SUBJECT: **2007-0822** – Application located at **734 Liverpool Way** (near Goldfinch Way) in an R-0 (Low-Density Residential) Zoning District.

Motion Appeal by a nearby resident of a decision by the Planning Commission approving a Use Permit to allow a modified design for an existing 9' 7" tall wood fence in the reducible front yard.

FIGURE 3 PROPOSED PLAN

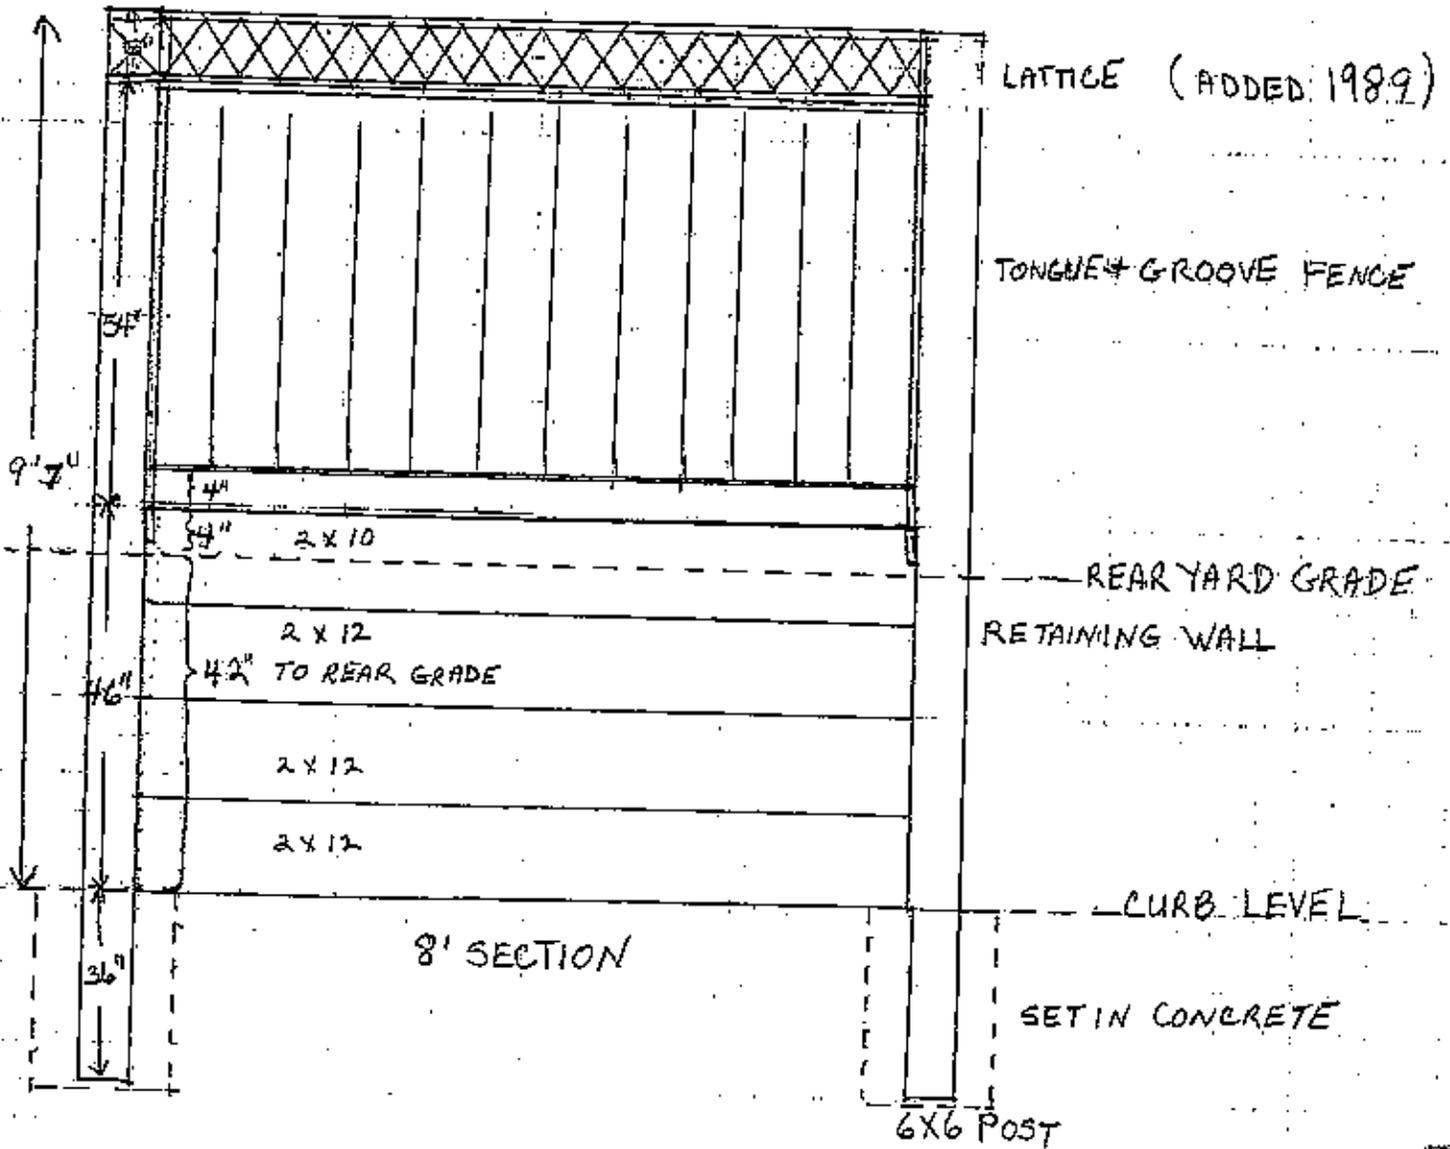
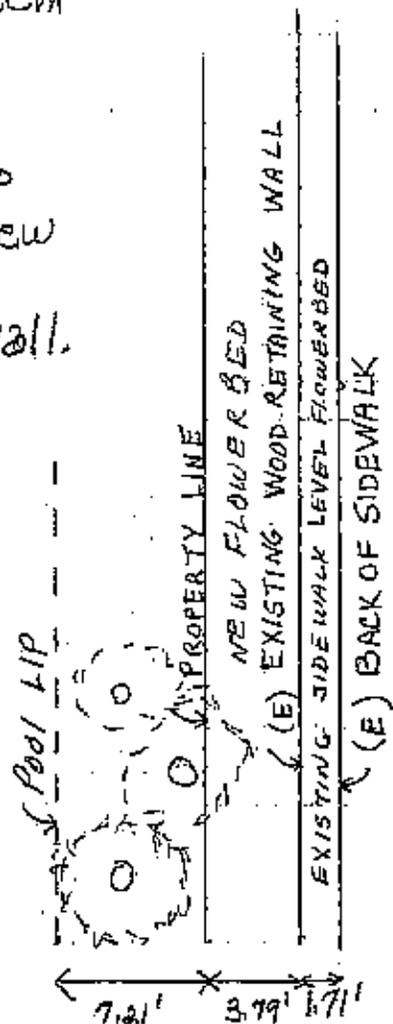
- 1) Reduce height of existing retaining wall to 36" and leave in place for soil erosion control.
- 2) Move existing fence back 3.79' to property line. Height of existing fence including lattice is 5.75'.
- 3) Move existing faucet back 4' to remain inside fence line.
- 4) Reconfigure existing irrigation system to supply water to both inside and outside flower beds.
- 5) Grade new outside flowerbed to accommodate a 4-6" drop from new fence line at existing elevation to new lower height of retaining wall.

ELEVATION LEVELS

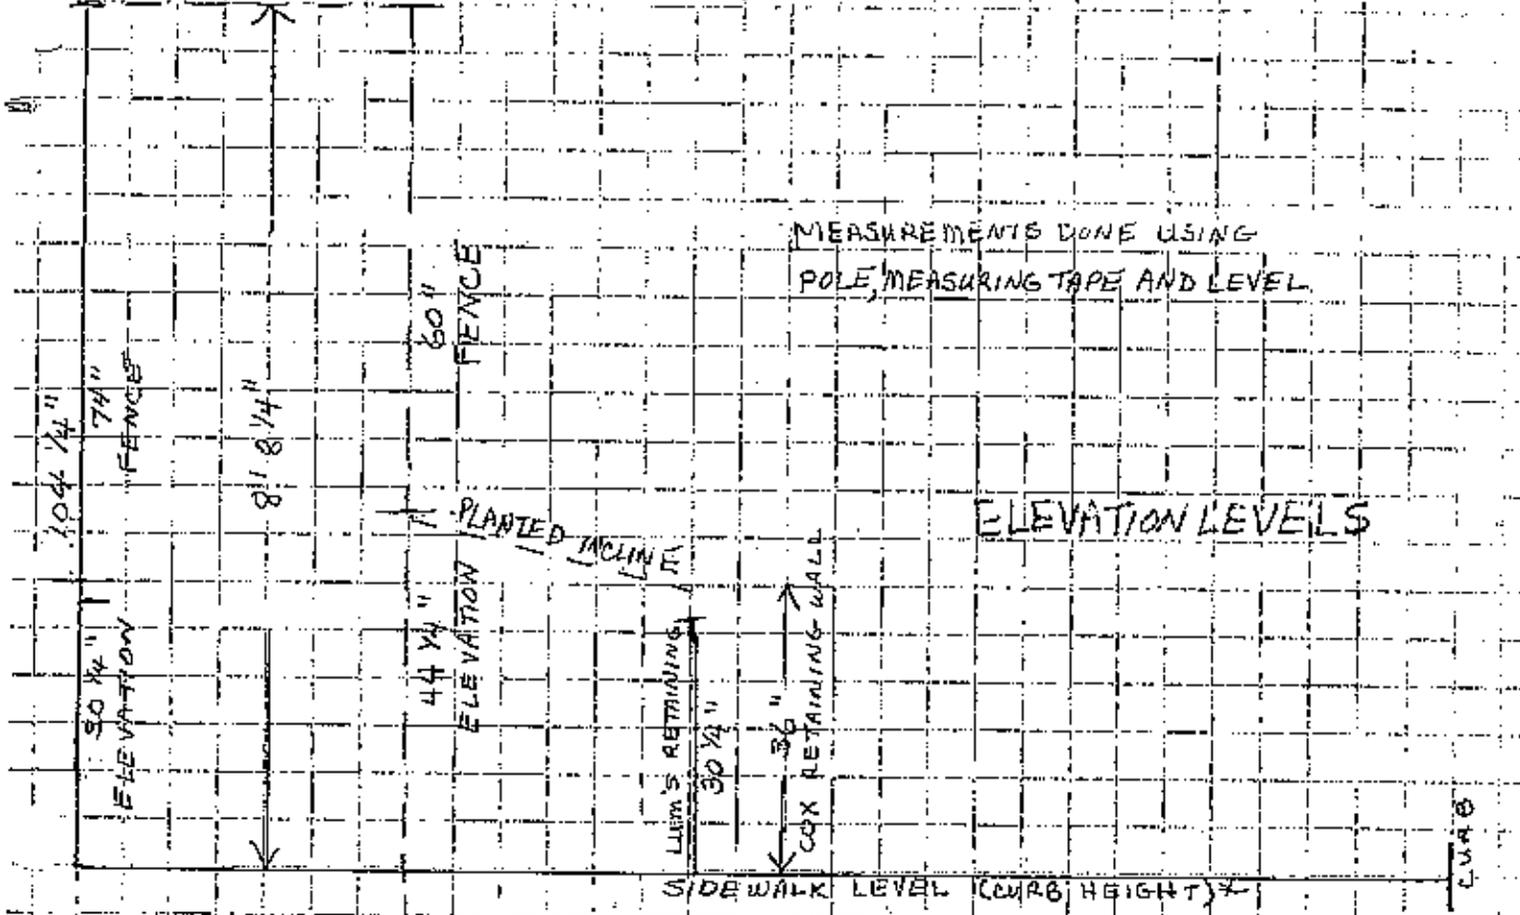
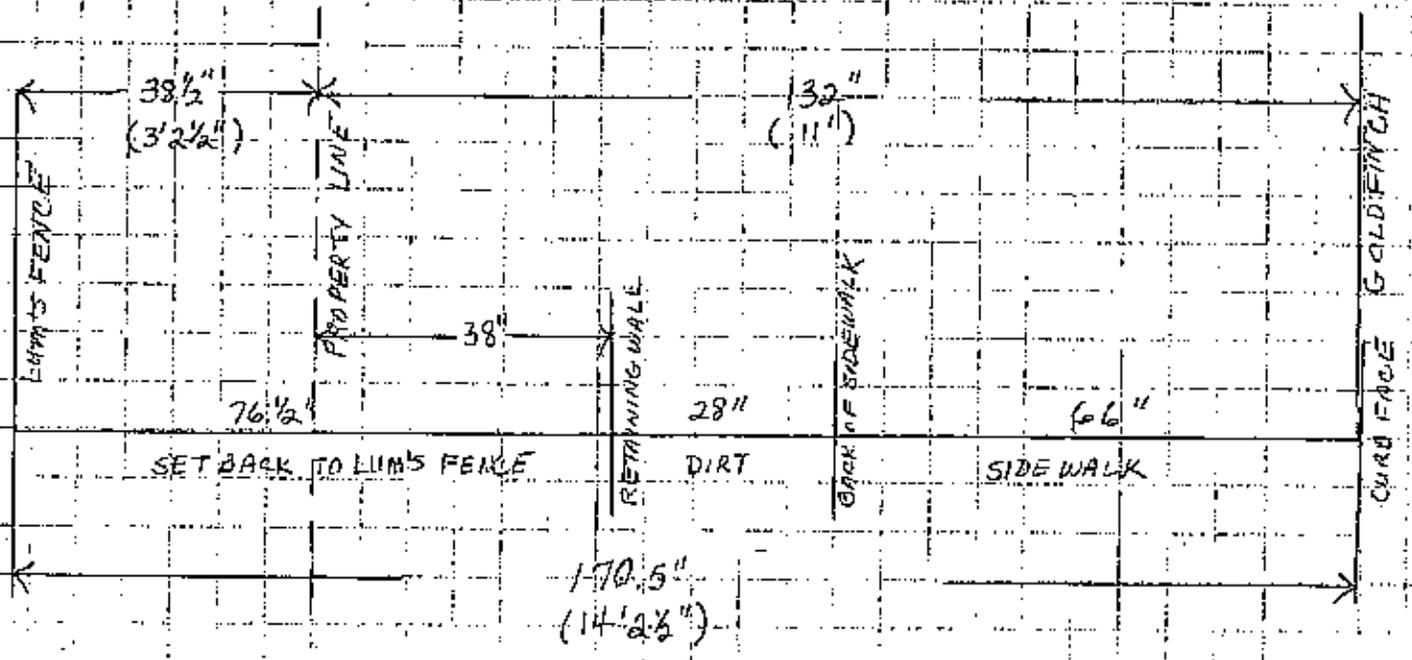
* NOTE: THERE IS A 3" HEIGHT DIFFERENCE BETWEEN TOP OF CURB AND BASE OF RETAINING WALL; 1 1/2" DIFFERENCE BETWEEN TOP OF CURB AND BACK OF SIDEWALK AT THE POINT WHERE PROPERTIES JOIN.

RETAINING WALL SECTION:

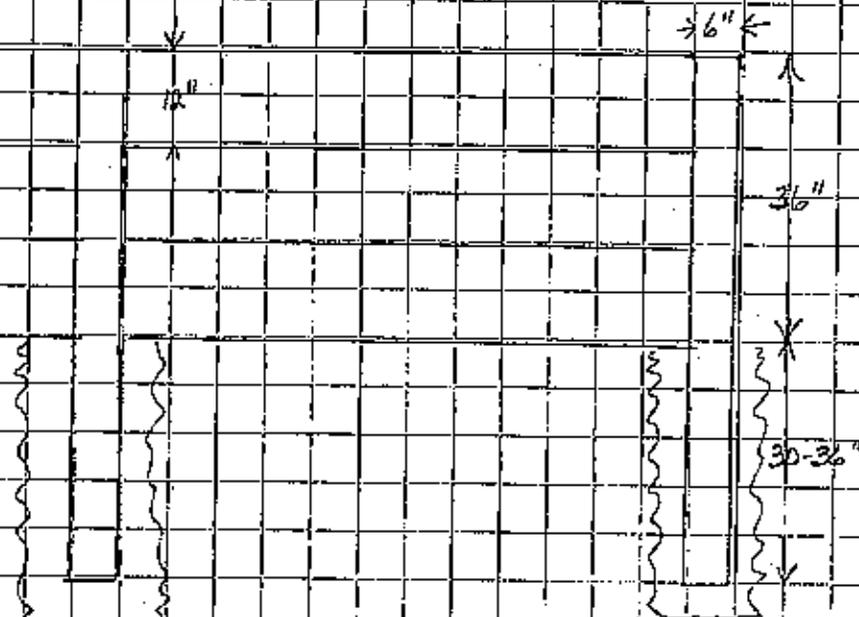
HEIGHT: 36" FROM GROUND LEVEL (3 2'x12" TREATED WOOD)

DEPTH: 2'
